September 6, 1991

Re: ACHCS Letter of 8/7/91 regarding ARCO Station #276 at
10600 MacArthur Blvd., Oakland, CA

I have received your letter dated August 7, 1991 submitted in response to ARCO's Work Plan for Subsurface Investigation and Remediation and Addendum One to the Work Plan both dated June 27, 1991. Additionally your comments also pertained to ARCO's Quarterly Groundwater Monitoring Report dated July 11, 1991.

PRELIMINARY TIME SCHEDULE
ARCO Station 276
10600 MacArthur Boulevard
Oakland, California

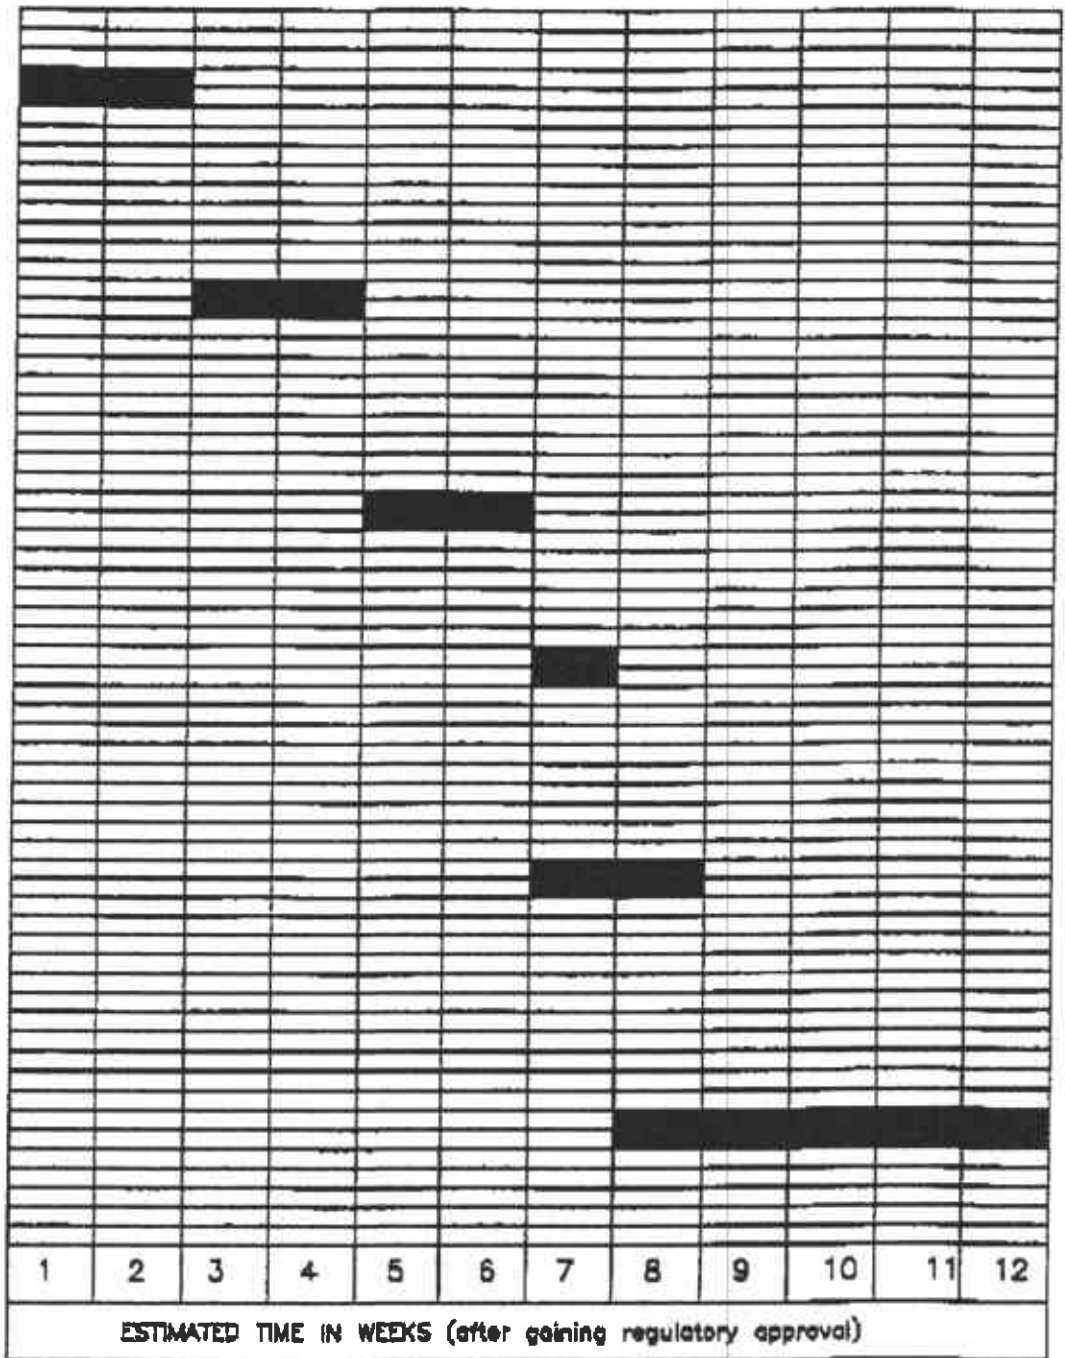
1. All proposed activities are to be tasked out with a committed time line for the initiation and completion of each task.

As I'm sure you are aware the schedule for completion of assessment and remediation activities are often controlled by factors beyond the guidance of both ARCO and the lead agency. How much time to allot for certain phases of the job can be beyond the control of ARCO and our consultant. For example, some of these factors are private and public access, regulatory review process, and unpredictable engineering and geological aspects which can significantly effect our time schedule. To include a "committed time line for the initiation and completion of each task" will most likely prove to be a wasted effort. However, as requested we will include an estimated best guess schedule for completion of the tasks which attempts to estimate permitting and work plan approval time requirements.

**GENERALIZED SITE PLAN
ARCO Station 276
10600 Mac Arthur Boulevard
Oakland, California**

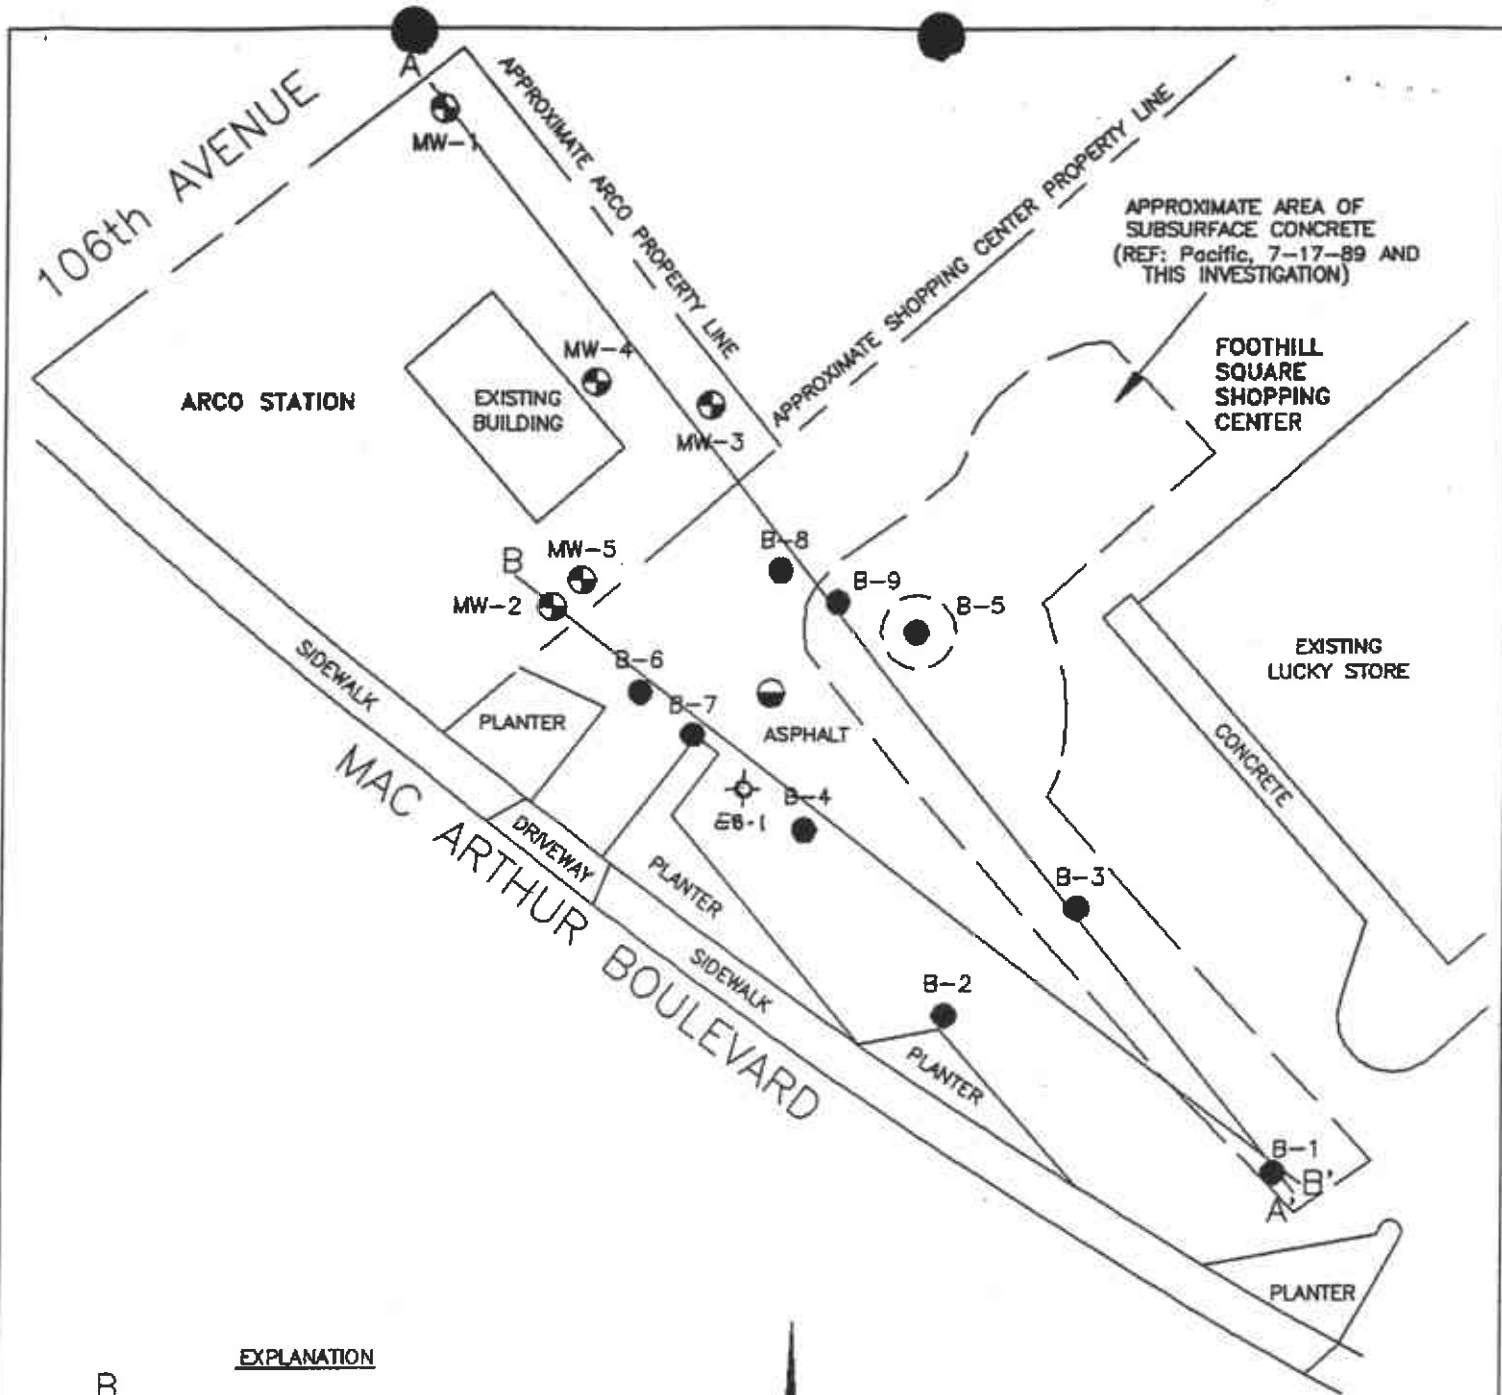
Additionally, the location of Kaldveer's boring EB-1 is erroneously located on Figure 2 of their 10/7/88 report; the boring is approximately located as shown on the attached surveyed map and is located near boring B-4 which was drilled by Applied Geosystems on 8/4/89. A soil sample from boring B-4 obtained at a depth of 26.5 feet was analyzed for pesticides and PCBs on 8/18/89 by Anametrix, Inc. The soil sample did not contain pesticides or PCBs although gasoline constituents were detected (see attached analysis data sheet).

ARCO requests that the ACHCS withdraw requirement number 5 because of the uncertainty in the analytical existence of pesticides and PCBs as documented in the Kaldveer report and that a subsequent nearby sample did not detect pesticides and PCBs in the soils at a depth similar to that sampled by Kaldveer. Additionally, pesticides and PCBs are not constituents of gasoline and their existence, if any, would not be associated with a subsurface gasoline release. Finally, the location of the sample obtained by Kaldveer was obtained approximately 60 feet from the ARCO property line on land which housed a plant that manufactured tractors, trucks, and motor buses from 1914 to 1960; suggesting that the pesticide and PCB contamination, if any, could be the responsibility of other parties.
